# United States Patent and Trademark Office

APPLICATION NO.	FILING DATE	FIRST NAMED INVENTOR	ATTORNEY DOCKET NO.	CONFIRMATION NO.
09/737,770 12/18/2000		In-Duk Song	8733.339.00	8950
30827 75	90 06/30/2005	EXAMINER		
MCKENNA LONG & ALDRIDGE LLP 1900 K STREET, NW WASHINGTON, DC 20006			RUDE, TIMOTHY L	
			ART UNIT	PAPER NUMBER
	,	2883		
			DATE MAILED: 06/30/2005

### **DETAILED ACTION**

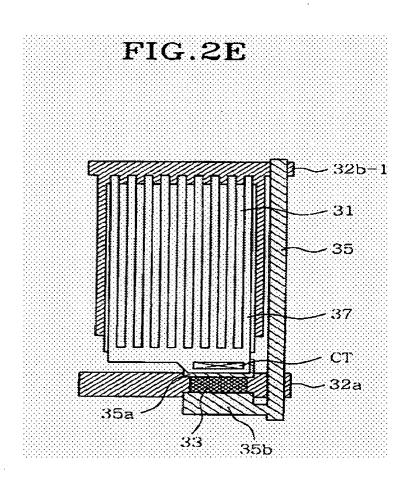
APA discloses in Figures 7A and 7B (more clear illustration than Figure 8 in these regards, Figure 8 is objected to above) that the scan line, 2 (gate line), is conventionally formed on the substrate, 1A, and that the reference signal line, 4 (common line), and the reference electrode, 14 (common electrode), are also formed on the same substrate (Applicant's wherein the common electrode is formed on the substrate like the gate line) and a are covered by a first insulating film, 11 (gate-insulating layer).

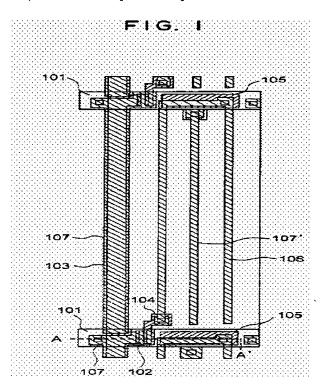
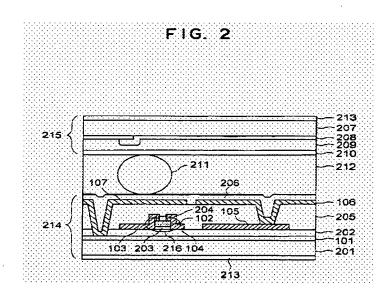
Wakagi teaches common electrodes having finger portions arranged in parallel to provide adequate lateral spacing between common electrodes and pixel electrodes to improve aperture ratio [col. 5, lines 31-44] for better display performance.

Wakagi is evidence that ordinary workers in the art of liquid crystals would find the reason, suggestion, or motivation to add common electrodes having finger portions arranged in parallel to provide adequate lateral spacing between common electrodes and pixel electrodes to improve aperture ratio for better display performance.

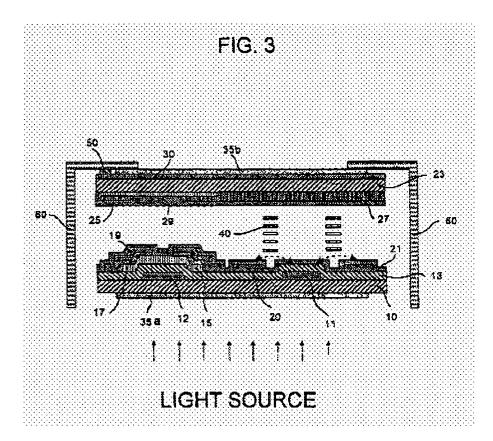
Son teaches in Figure 3, an LCD device, further comprising a light-shielding layer, 25, (Applicant's black matrix) on the second substrate, 23, (para 0029).
